EXISTING 5TH FLOOR PLAN
RENOVATE ROBOTICS BUILDING
UNIVERSITY OF KENTUCKY

UK
 CPMD PROJECT #: 2353.0
 CONSTRUCTION DOCUMENTS
 30 MAY 2013

THE BIDDING AND GENERAL DOCUMENTS, TECHNICAL SPECIFICATIONS AND DRAWINGS ARE CHANGED IN ACCORDANCE WITH THE FOLLOWING. PLEASE SUBMIT A PRICE PROPOSAL BASED ON THE CHANGE ORDER INFORMATION AND ANY ACCOMPANYING DRAWINGS FOR APPROVAL AND INCLUSION INTO THE CONTRACT.

REVISED ROOF PAD SIZE		 UK UNIVERSITY OF KENTUCKY PROJECT # 2353.0	 bender associates architects 1000 UNIVERSITY AVENUE, SUITE 100 LEXINGTON, KY 40506-0100	DATE:	REVISION
RENOVATE ROBOTICS BUILDING UNIVERSITY OF KENTUCKY				14 NOV 2013	DRAWING NO.
					RA.1b

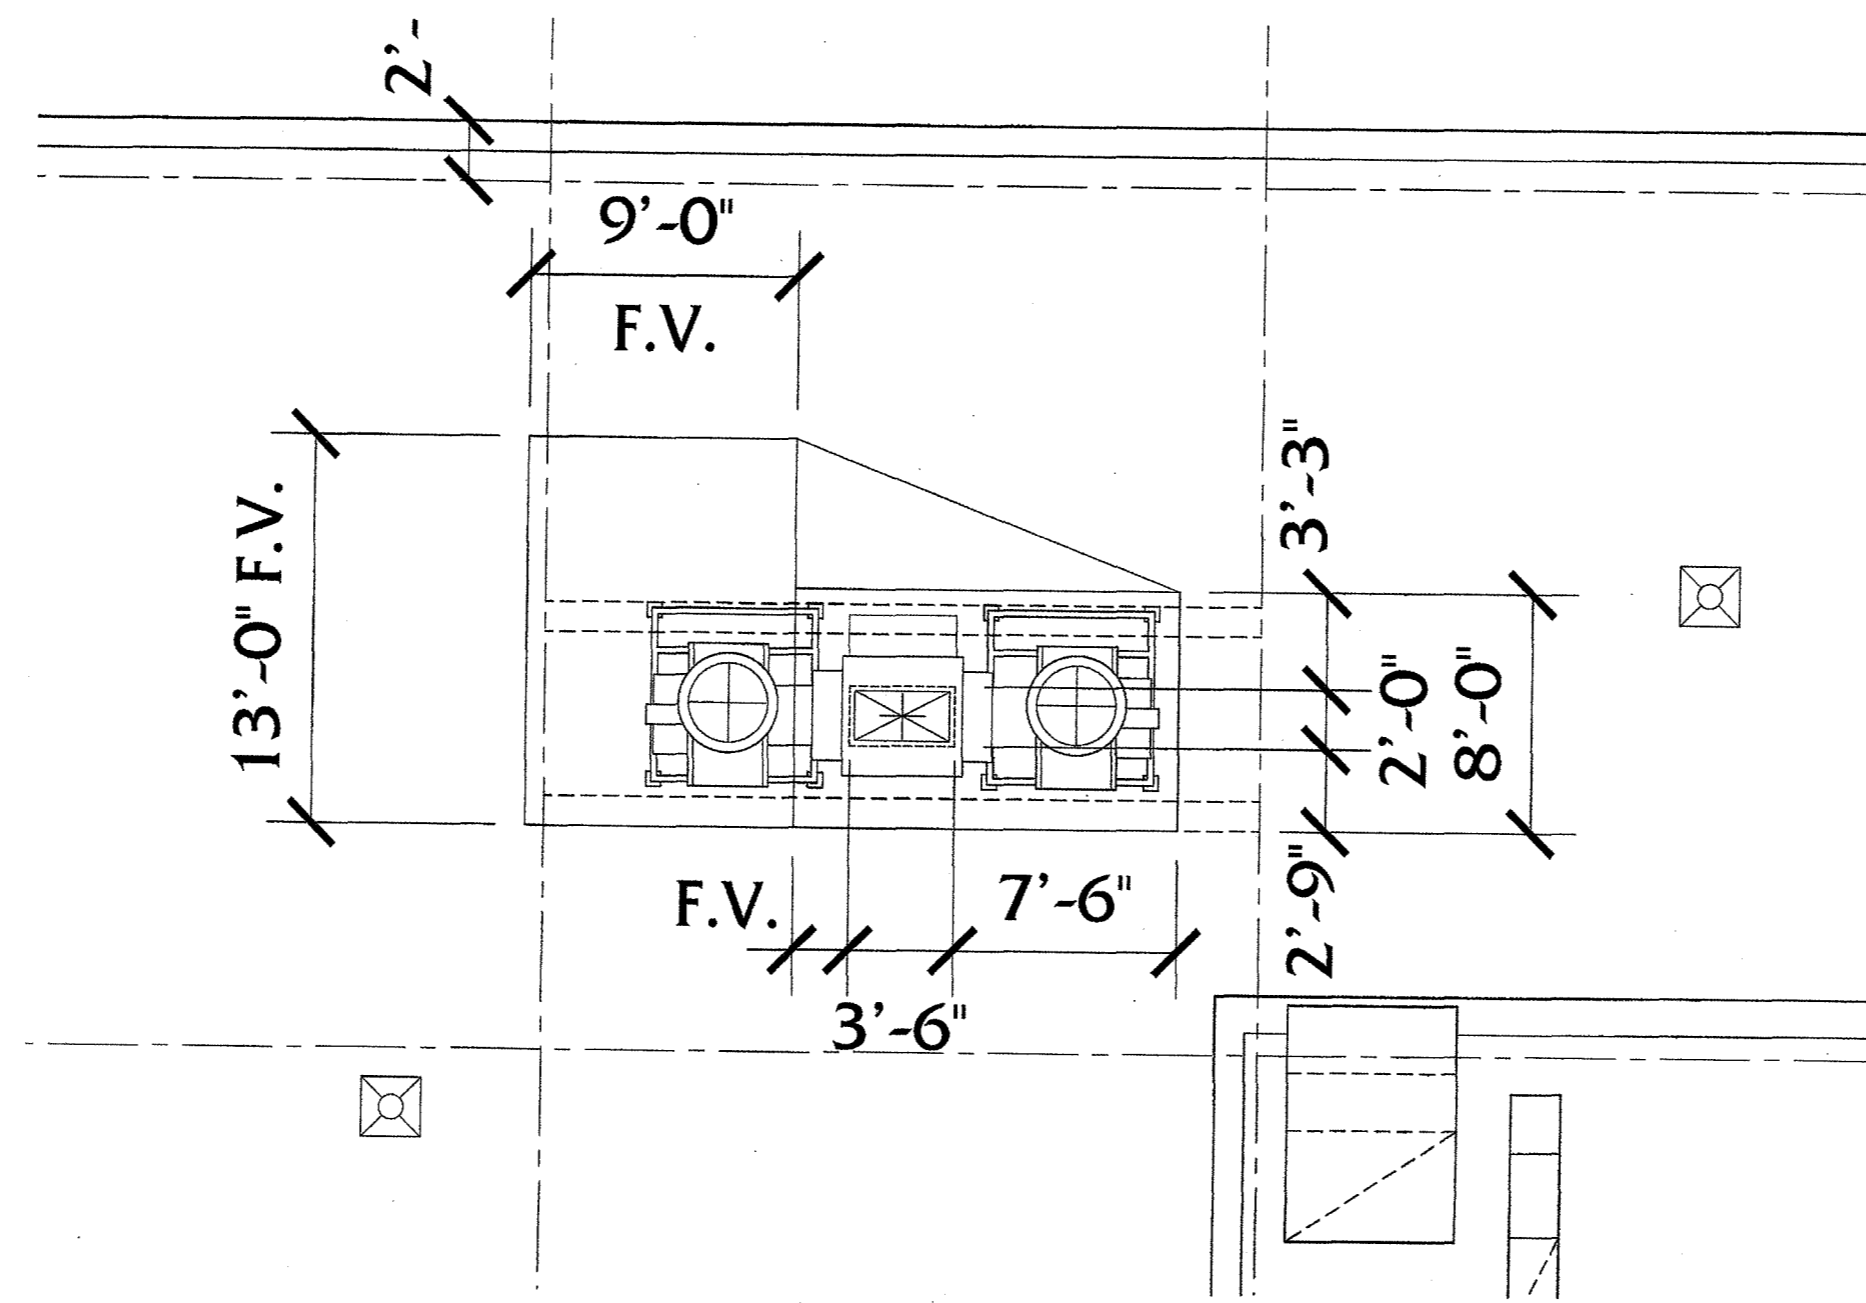
Extend 3/8" wall corners

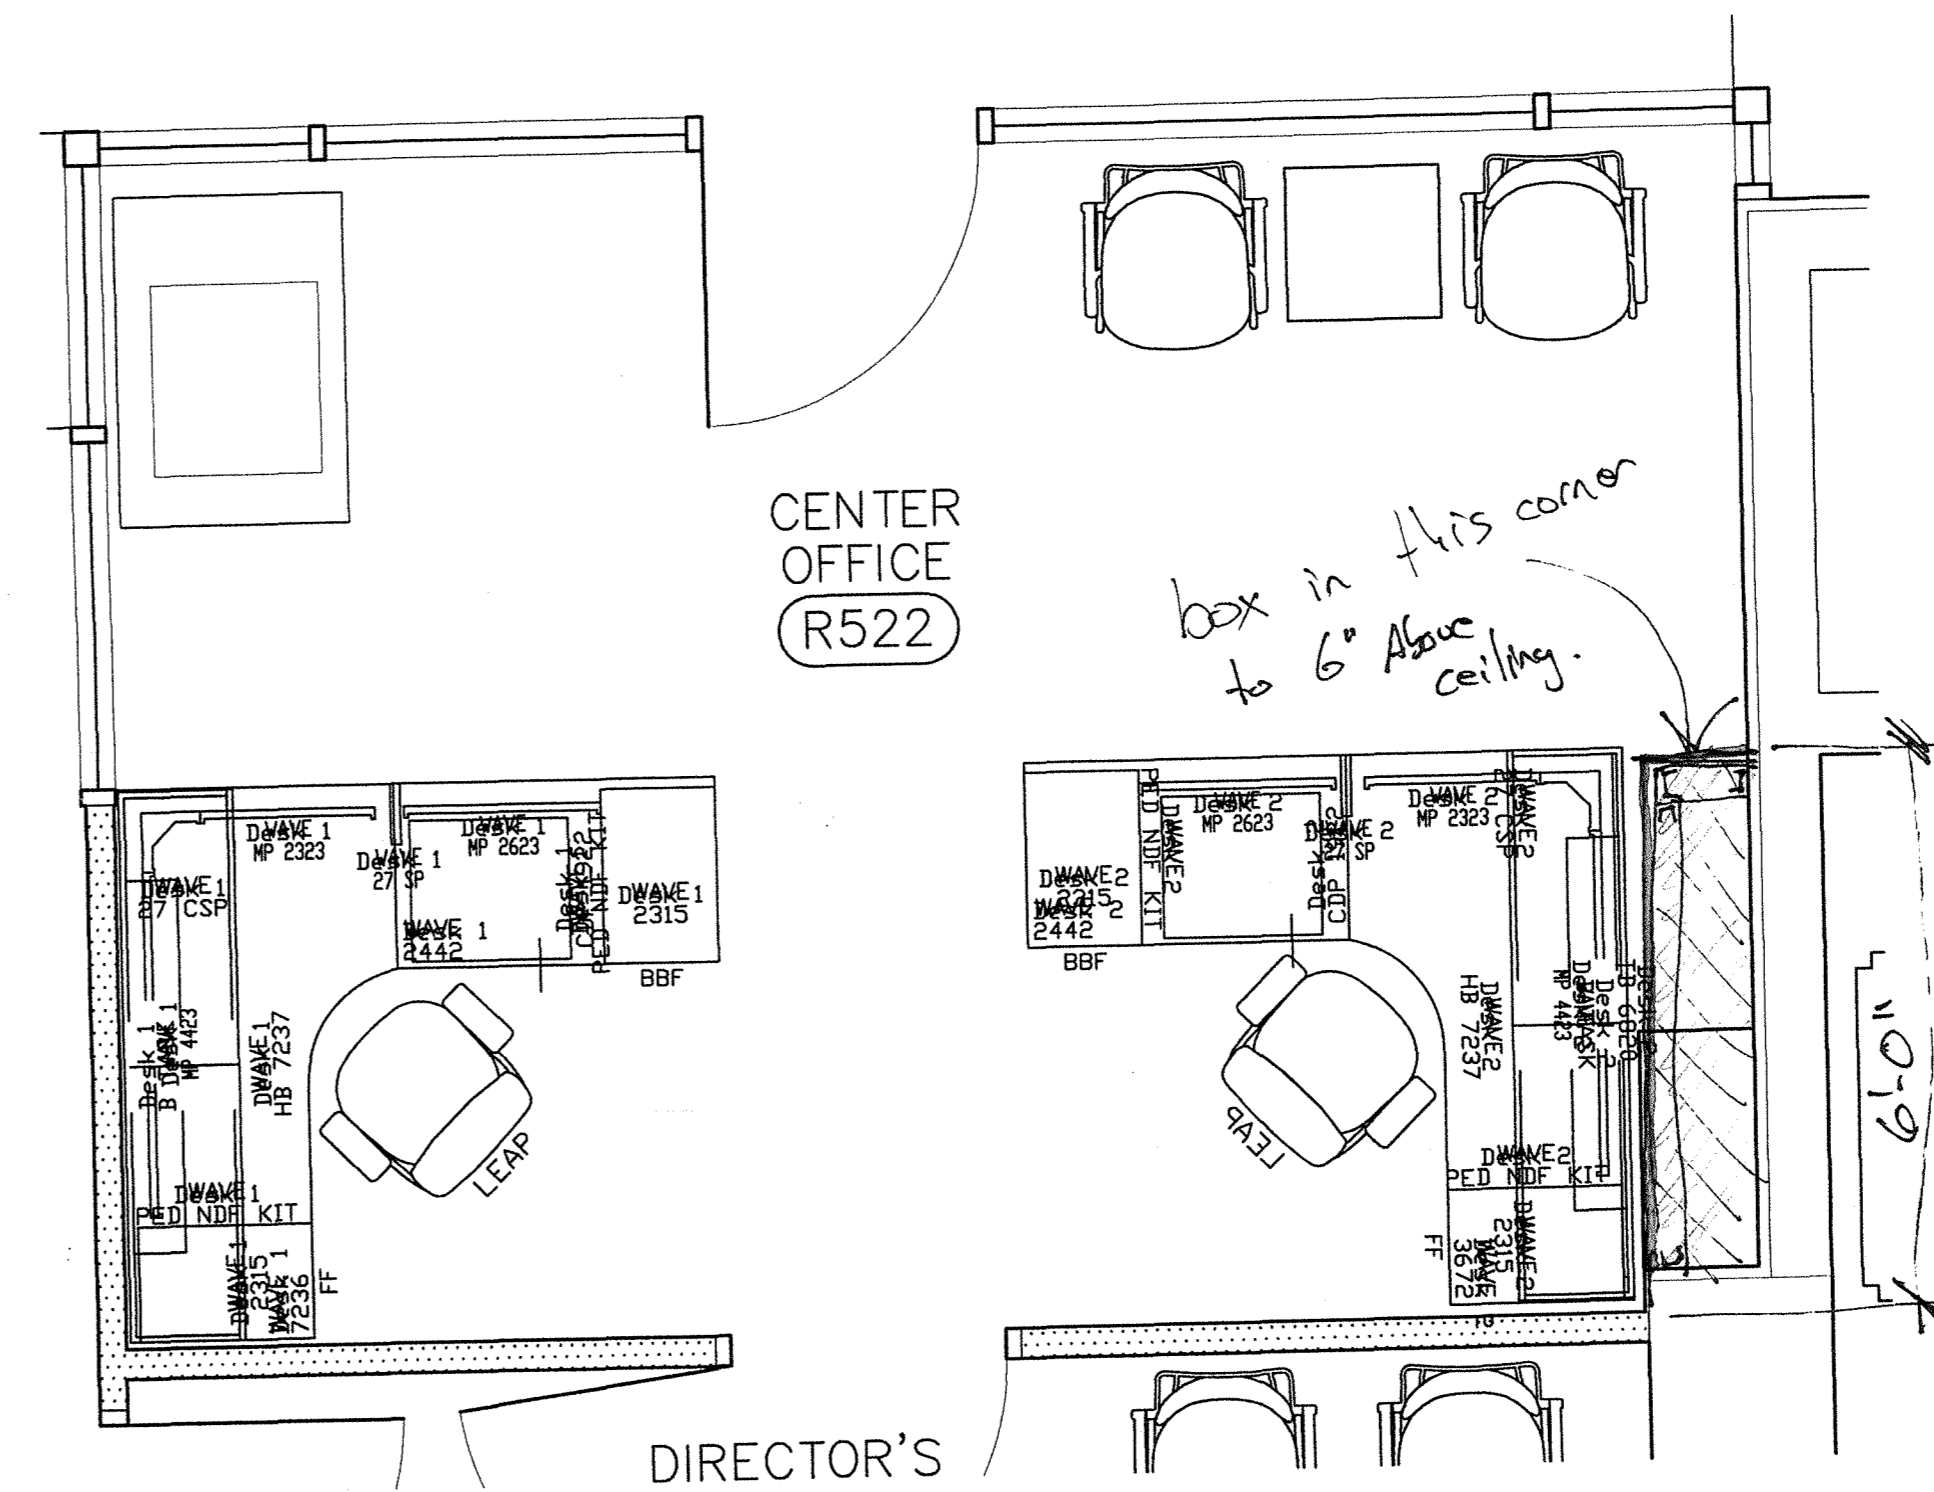
9'6" height to 9'2" (9'0") Steve White
 RFI #1 9/30/13
 in Corridor Phone

ENLARGED LAB R509 PLAN - Yu
 SCALE: 1/2" = 1'-0"
 PLAN NORTH

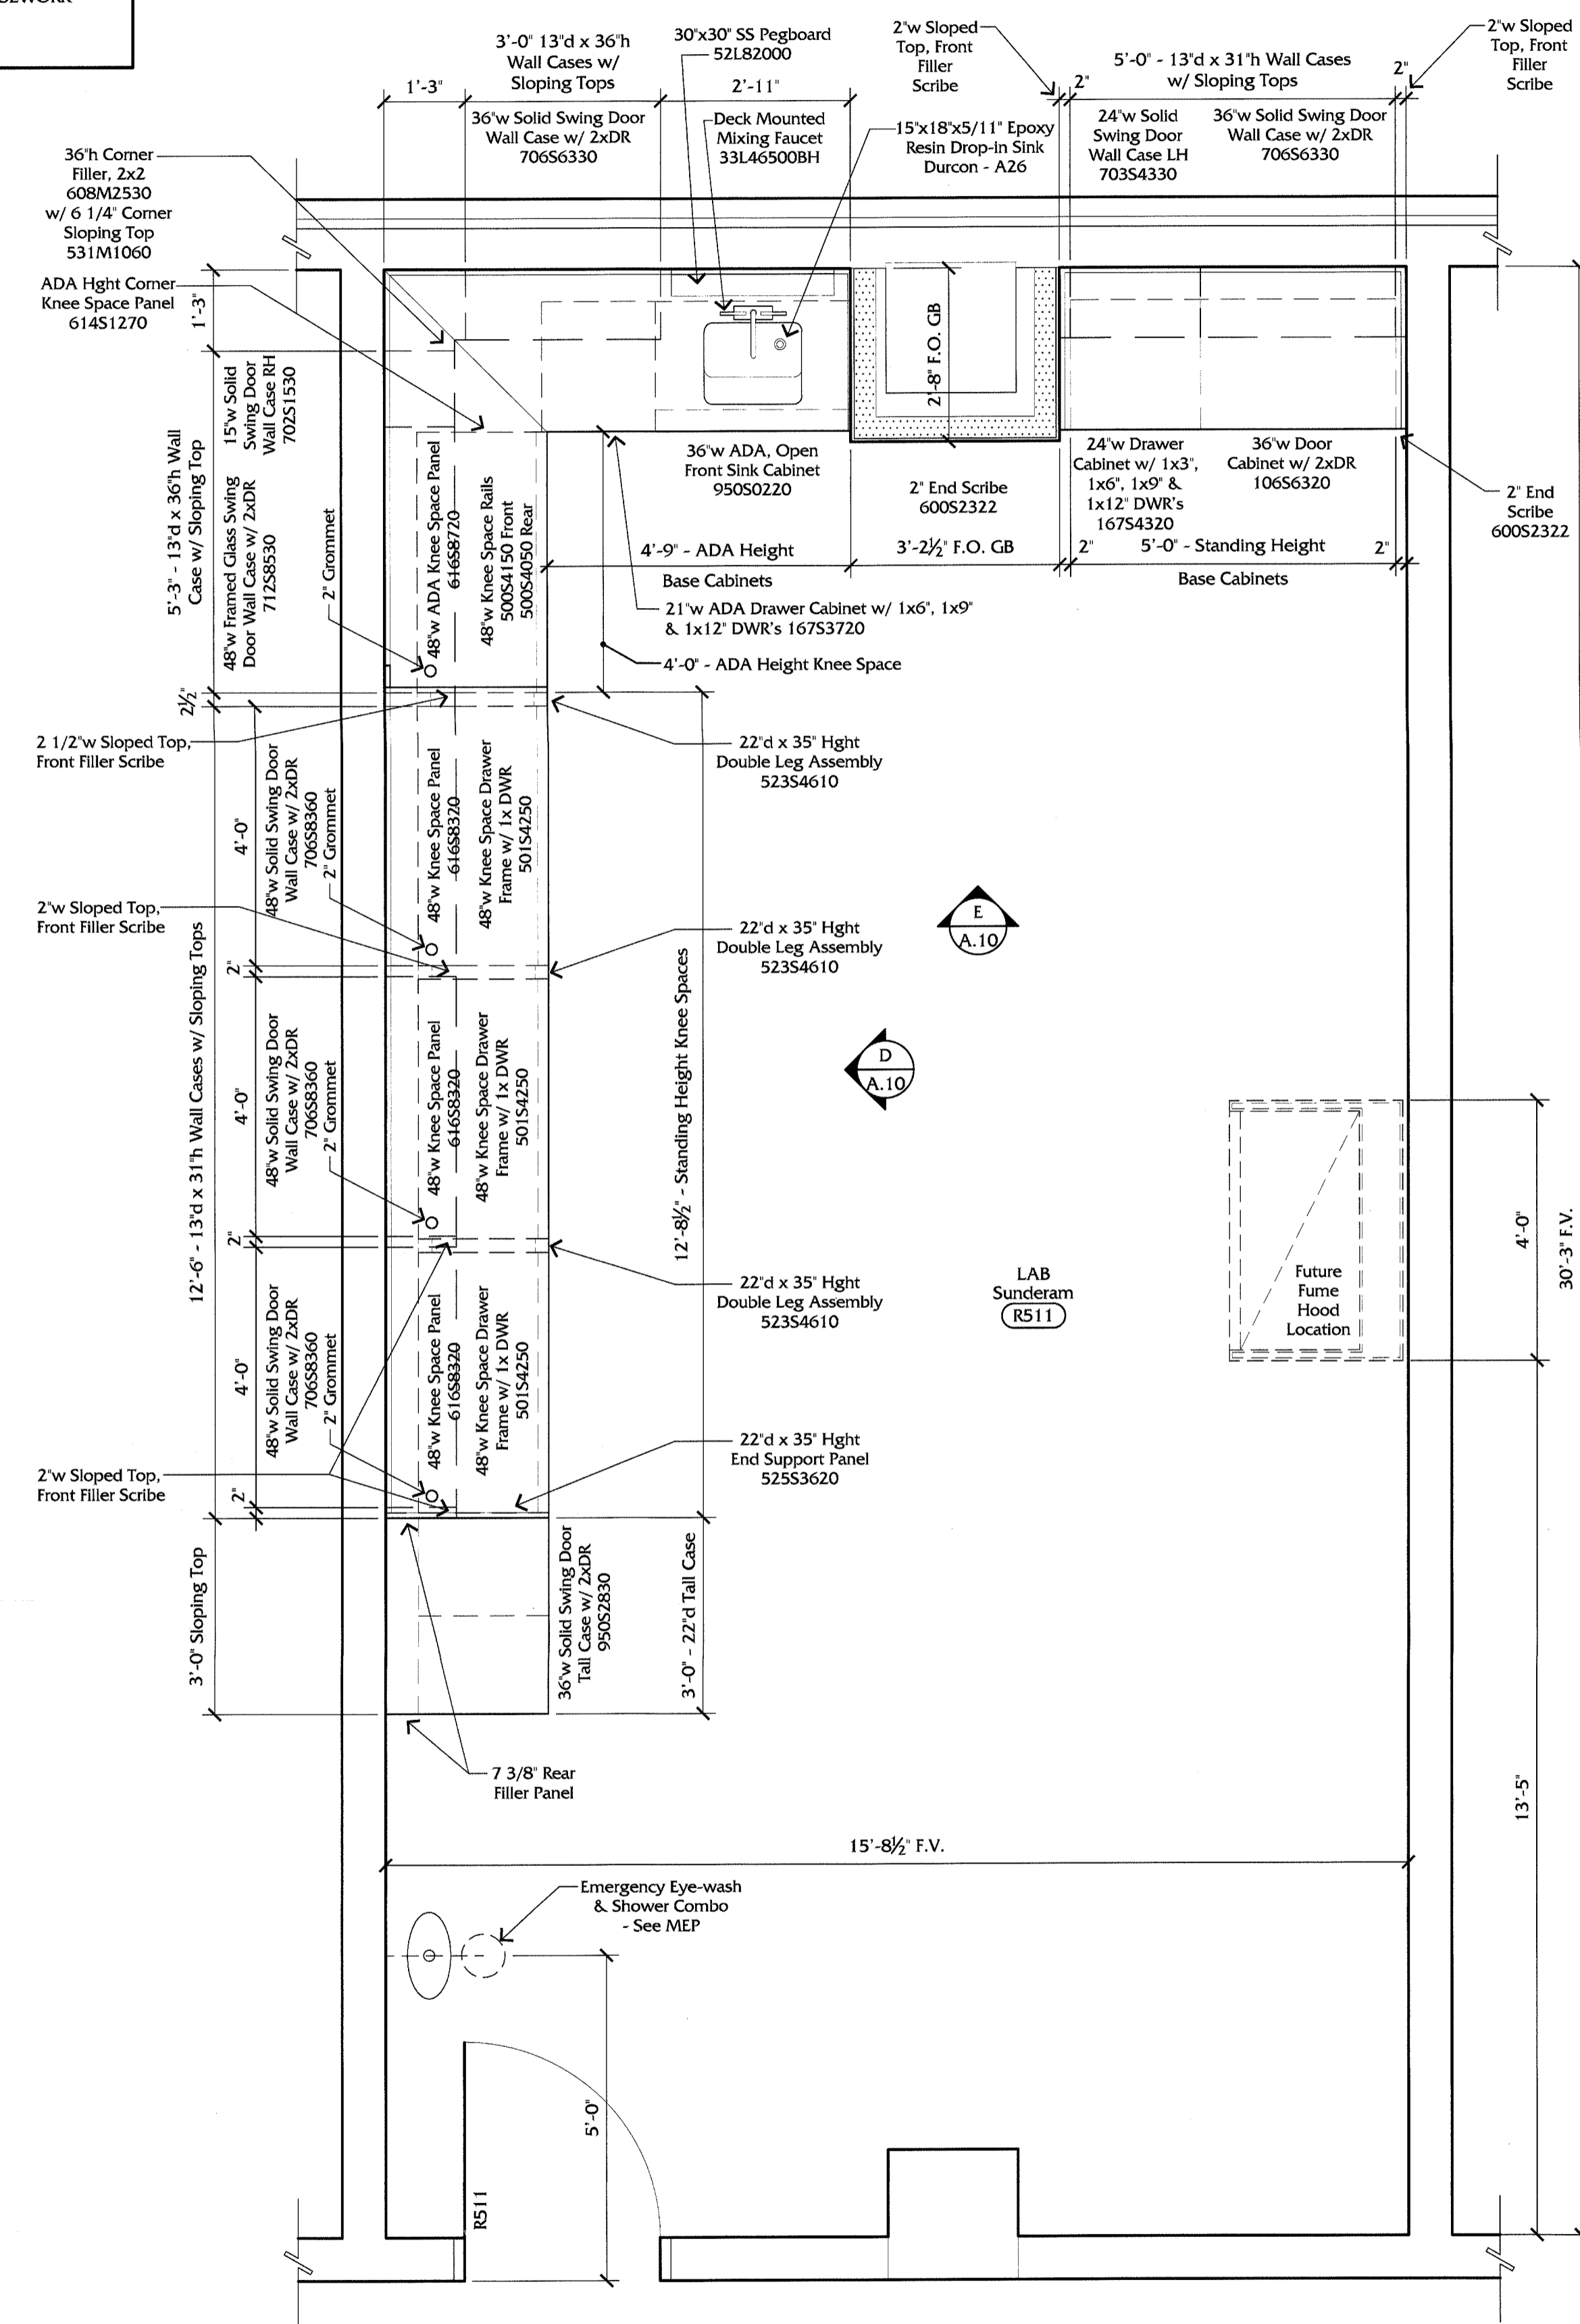
I spoke with Brian about this at the job meeting. Please move the studs for the chase towards the door. It will not affect the casework layout on this side. No need to cut out the plate, we have plenty of room. Also, please note that on the plans I called out dimensions to the F.O. GB not F.O. stud.

Drawings (H.1.1 R1 and H.1.2 R1) modified the 4th and 5th floor duct bringing a 14" round duct through the floor and in the chase of Lab 509. As you can see from the photo, the duct will not fit in the new chase. The duct will fit across the back wall, but will need to come out further on the side closest to the door to accommodate the new duct. Please verify that this is how you want us to proceed. Thank you.

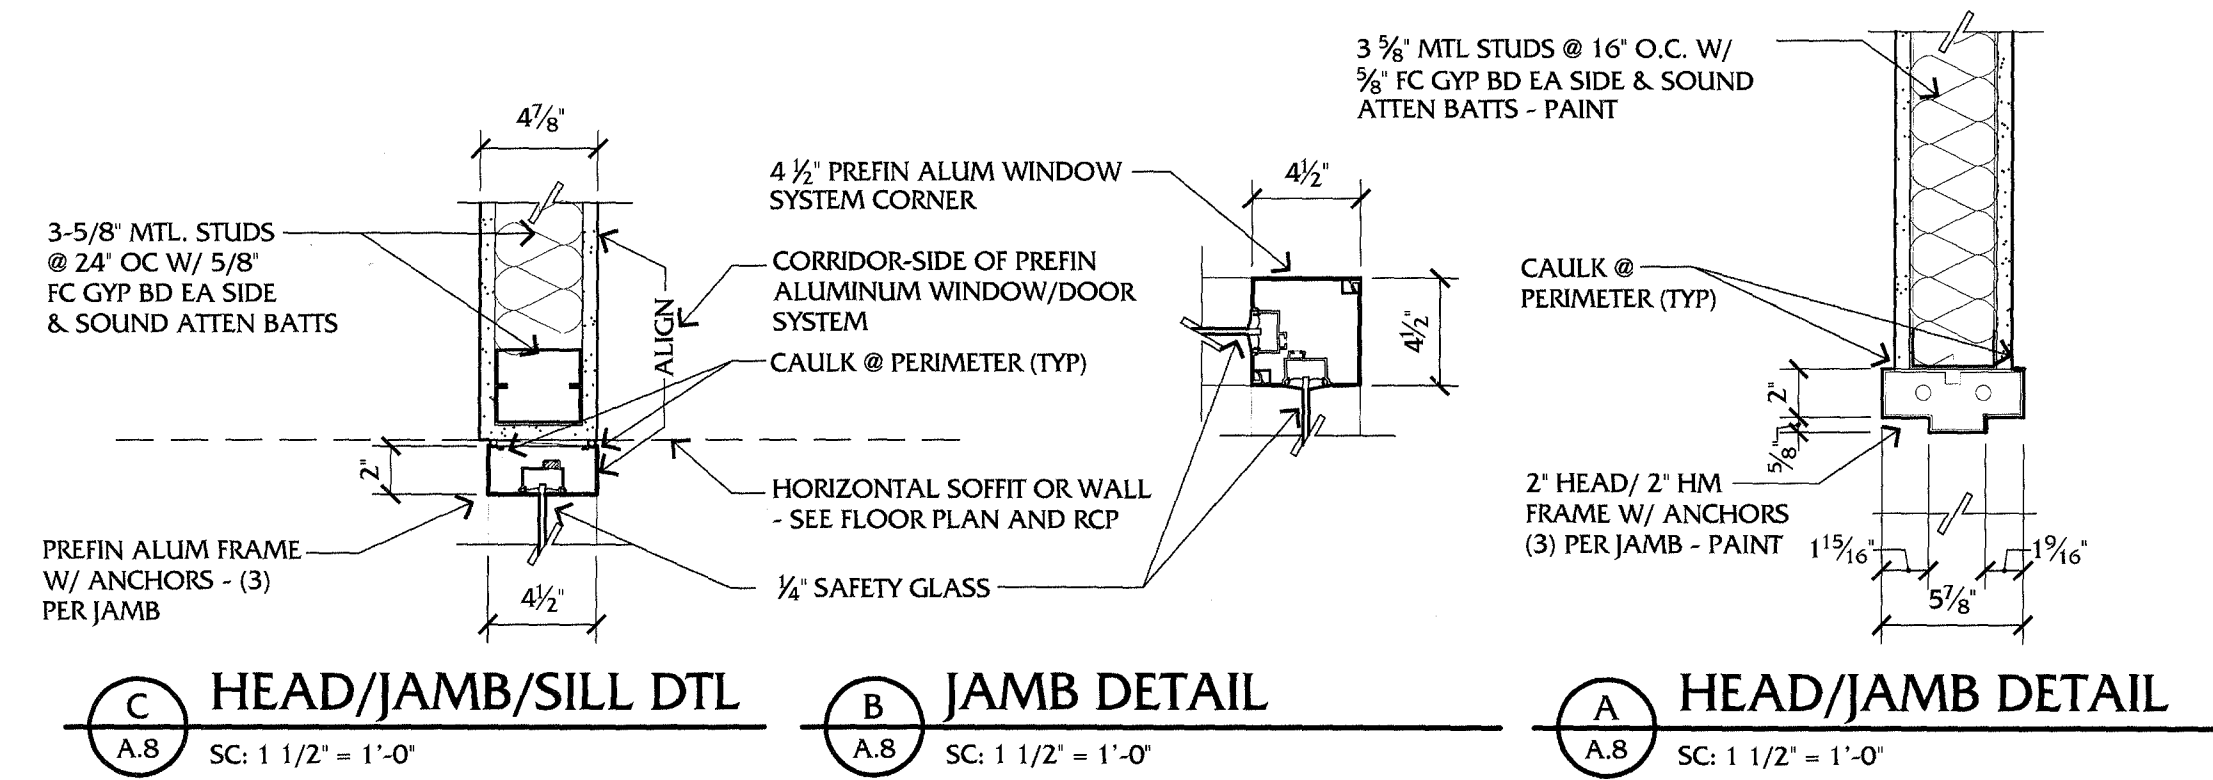
1. Please provide pricing for a furred wall that is located behind the new casework in Rooms R508A & R508B.
2. Extend new furring to 6" above the finished ceiling.
3. Consult the laboratory casework shop drawings for the length of cabinets.
4. Use as minimum a depth studs a possible to facilitate the new vent line.
5. Studs shall be 16" O.C. and fastened to the CMU at mid point.
